8. **Project# 1007697/1007685**
09DRB-70193 MINOR - PRELIMINARY/
FINAL PLAT APPROVAL

11. **Project# 1007822**
09DRB-70195 SKETCH PLAT REVIEW
AND COMMENT

DEVELOPMENT REVIEW BOARD--SPEED MEMO

DRB-1007822 Item No. 11 Zone Atlas J-14

"EXHIBIT"

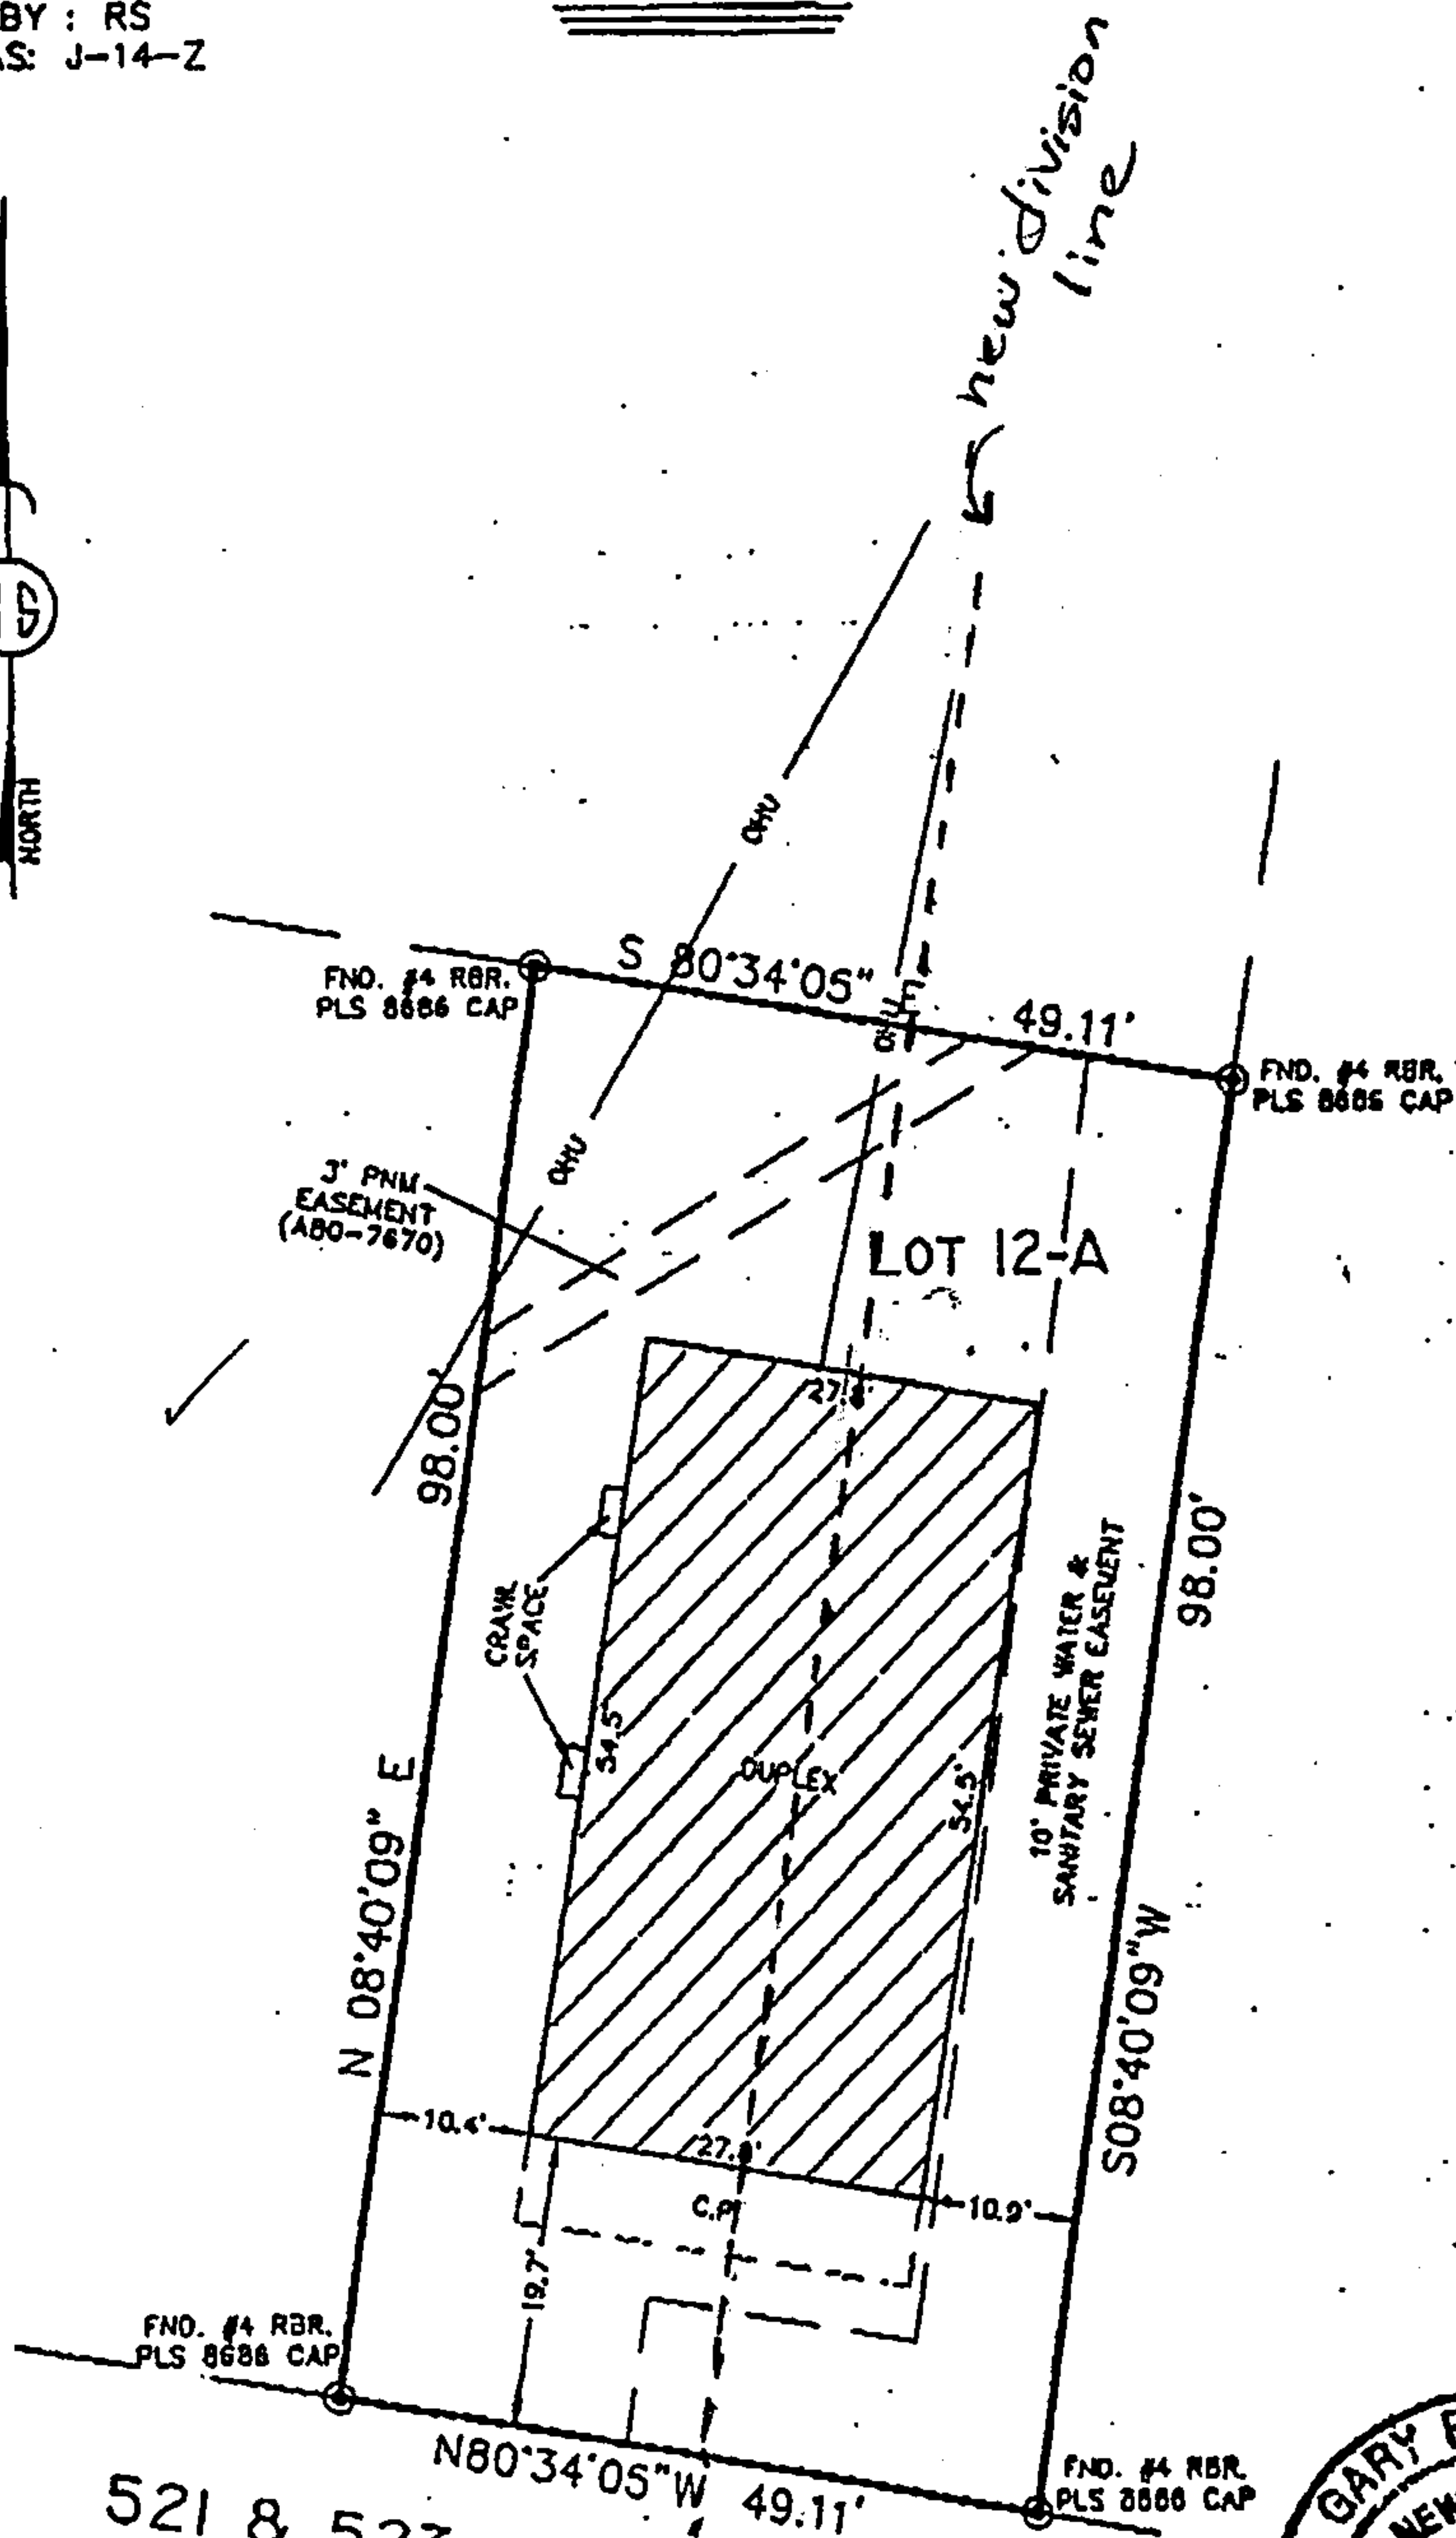
1. If the property is to be subdivided, the dwellings must have separate water meters and sanitary sewer service lines/connections to main.
2. The only way for the dwellings to share water/sewer service is to remain as a single lot.

Division of a property into a Condominium is not under the jurisdiction of the City's Subdivision Ordinance. Division into townhouses would require a subdivision plat and compliance with all other City ordinances – a registered architect or engineer would have to certify that the building meets the building code for townhouse (certified firewall, etc.). An equal division of this existing lot would meet the minimum zoning size requirements of the Downtown Neighborhood Sector Development Plan, but individual water and sewer connections will be required – refer to comments from the Albuquerque Bernalillo County Water Utility Authority (ABCWUA).

1. Office use is permitted if the non-residential floor area does not exceed one-half of the gross floor area – refer to the sector plan and the City Zoning Code.
2. Refer to comments from ABCWUA.
3. Utility companies may review and sign-off a subdivision plat.
